# HARVEST CHAPEL 2ND ADDITION

## WICHITA, SEDGWICK COUNTY, KANSAS

RE: S/D 99-83 -- Final Plat of HARVEST CHAPEL 2<sup>ND</sup> ADDITION

CASE NUMBER: S/D 99-83 - HARVEST CHAPEL 2<sup>ND</sup> ADDITION

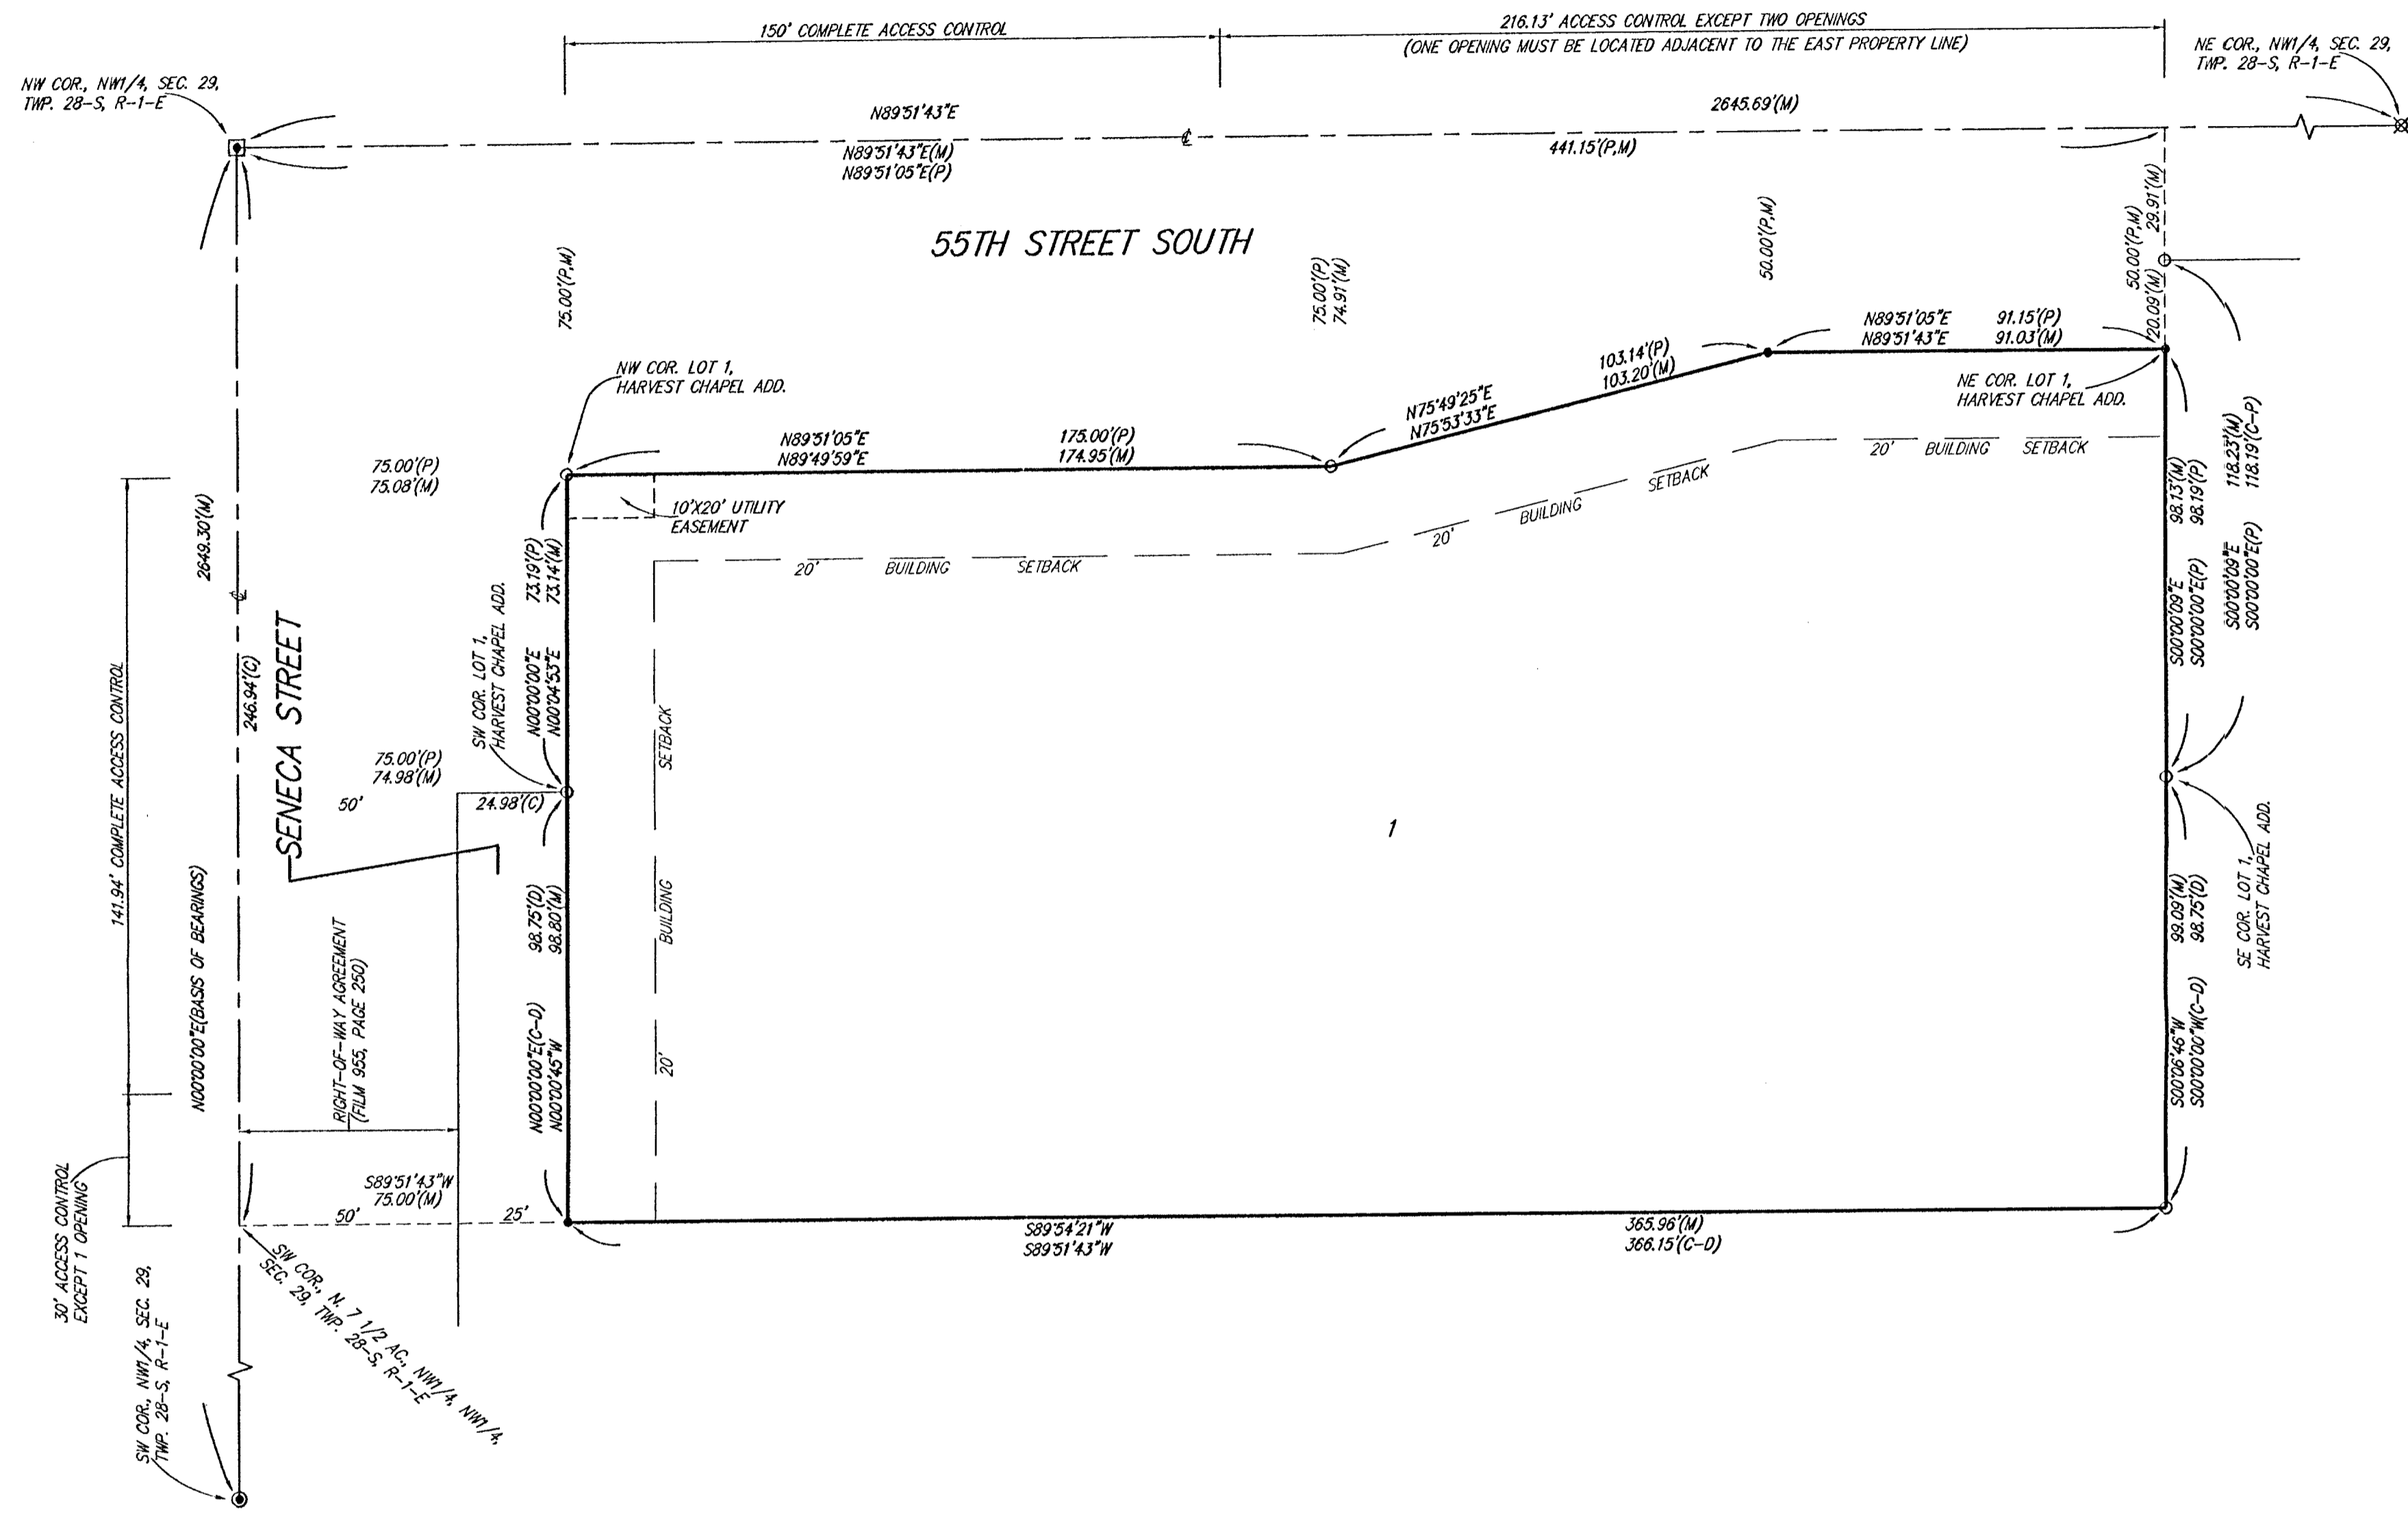
- A. City water is available to serve this site. City Engineering needs to comment on the need for any guarantees or easements. *A petition for sewer extension to the south line of the plat is required.*

- C. City Engineering needs to comment on the status of the applicant's drainage plan. *The drainage plan is approved. No guarantees are required. Drainage improvements will be required at time of the site development.*

- D. Traffic Engineering needs to comment on the access controls. The plat proposes two access openings along 55th St. South and one access opening along Seneca. Distances should be shown for all segments of access control. The final plat shall reference the access controls in the plat's text. The applicant shall guarantee the closure of any openings located in areas of complete access control. *Traffic Engineering requests an access opening to be located on 55<sup>th</sup> South along the plat's east line and on Seneca along the plat's south line.*

- H. The plat's text shall include language that a drainage plan has been developed for the plat and that all drainage easements, rights-of-way, or reserves shall remain at established grades or as modified with the approval of the applicable City or County Engineer, and unobstructed to allow for the conveyance of stormwater.

- N. Perimeter closure computations shall be submitted with the final plat tracing.
- O. Recording of the plat within thirty (30) days after approval by the City Council and/or County Commission.

The requested access controls have been denoted on the final plat.
- E. Traffic Engineering should comment on the need for improvements to perimeter streets. *No improvements are required.*
